City of Alexandria, Virginia

MEMORANDUM

SUBJECT: THE MADISON (800 NORTH HENRY STREET)
DSUP# 2007-0005
SUP (TMP) # 2007-00051

This memorandum serves as an addendum to the staff report for the December 4, 2007 hearing and addresses the points outlined above.

Fig.1 Belle Pre Bottle Company (1907)

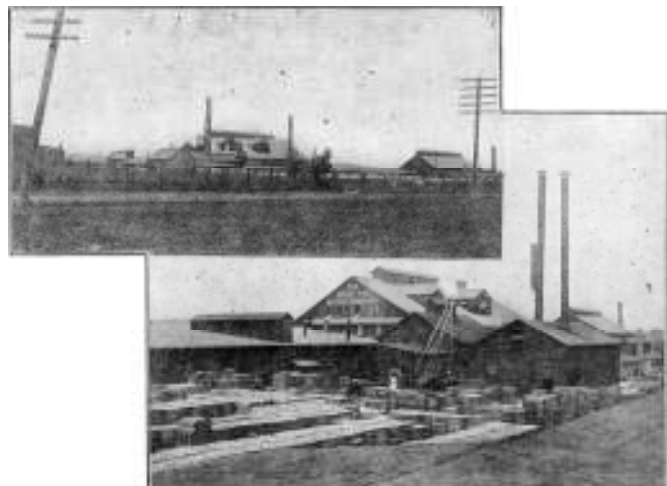
City records indicate that Montgomery Street did not exist in this block until approximately 1930 because of the Belle Pre Bottling Co, which occupied almost the entire site. (Fig. 1) The bottling plant existed on the site until approximately 1921 when it was destroyed by fire. The extension of Montgomery Street existed on the northern portion of this block for only a few years beginning in 1939. In 1954 the unused right-of-way was approved to be vacated by City Council Ordinance 805 to make room for the current building. When

Fig. 7 Front yards proposed along Fayette St.

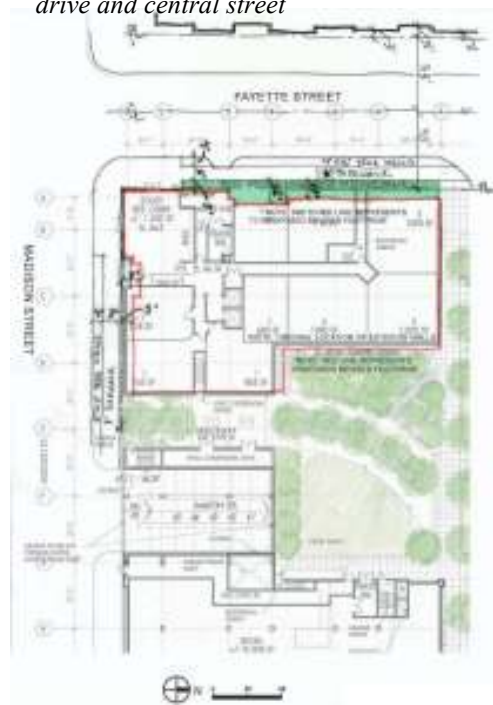
Similar to the approach in Eisenhower East, staff is recommending that the applicant provide ground level open space on-site but also contribute to an open space fund for the Braddock area that would enable the purchase of a useable consolidated park. Staff is also recommending additional front yards and areas for landscaping on Fayette Street. (Fig. 7)

Figure 12. Bulk plane requirements.

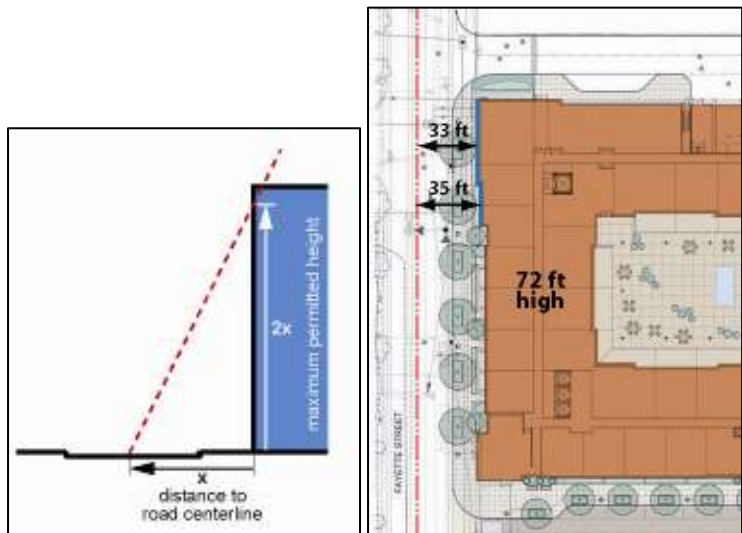
Although the CRMU-H zone does not have yard requirements, the Zoning Ordinance requires that the building be set back from the centerline of the street it faces a distance equal to at least half the height of the building at every point. The intent of this bulk plane/setback provision was to ensure an appropriate distance between buildings on each side of the street. At the northwest corner of the site along Fayette Street, the portion of the building that does not meet the setback requirements is 72 feet tall with a 33- to 35-ft. setback from the centerline. This setback rule requires a minimum 36-ft. setback from the centerline of

Fayette Street, and therefore, the portion of the building in this location either needs to be pulled back 1-3 feet or be lowered.
